REVIEW OF THE COLUMBIA/SNAKE RIVER TEMPERATURE TMDL FOR THE COLVILLE AND SPOKANE TRIBES

U.S. Environmental Protection Agency
Region 10
Seattle, Washington

George Bowie / Clayton Creager
Tetra Tech, Inc.
3746 Mt. Diablo Blvd., Suite 300
Lafayette, CA 94549
(925) 283-3771

September 14, 2002

Figure 2. Comparison of predicted and observed water temperatures at Bonneville Dam on the Columbia River for the period 1990-1994 (EPA, 2001).

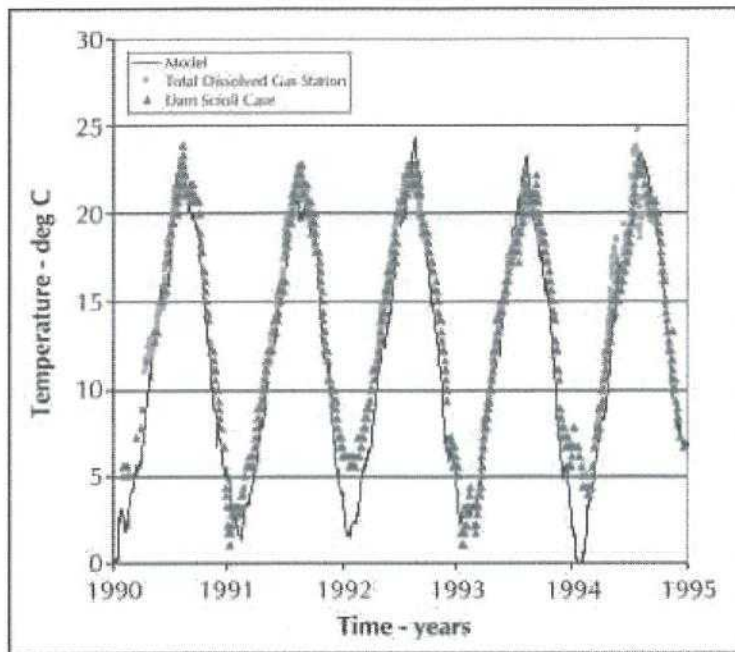
A one-dimensional model is also consistent with the available monitoring data throughout the system. Long-term monitoring records at most of the dams are available only at a single depth. The calibrated model gives very good results when compared with the field monitoring data. Both the magnitude and timing of human effects are well represented in the model. Figure 2 shows a comparison of the model results and field data at the Bonneville Dam on the lower Columbia River, and Figure 3 shows a similar comparison for the Ice Harbor Dam on the lower Snake River.

Figure 4. Comparison of predicted water temperatures at Ice Harbor Dam on the Snake River with the dams in place (current conditions) and with the dams removed (natural conditions) during 1990 (EPA, 2001).

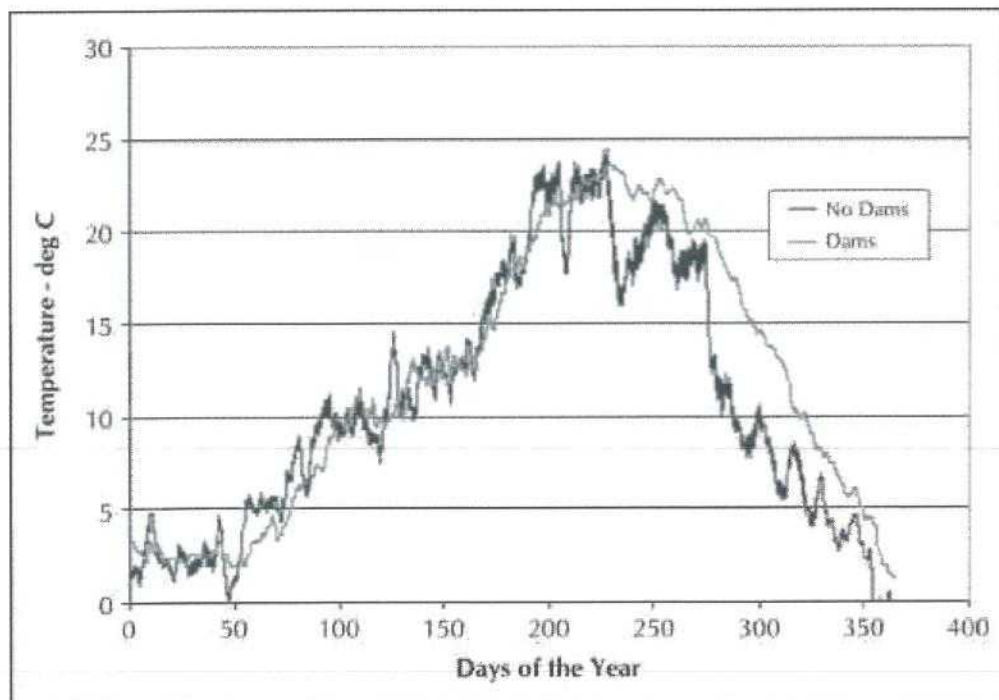
Comparison of these estimated natural temperatures with the current temperatures shows that the natural temperatures would fluctuate more widely due to both diurnal heating/cooling and day-to-day variations in the weather, and that the natural temperatures would cool much faster in the late summer and fall. These differences are illustrated in Figure 4 (for the Ice Harbor Dam on the Snake River).
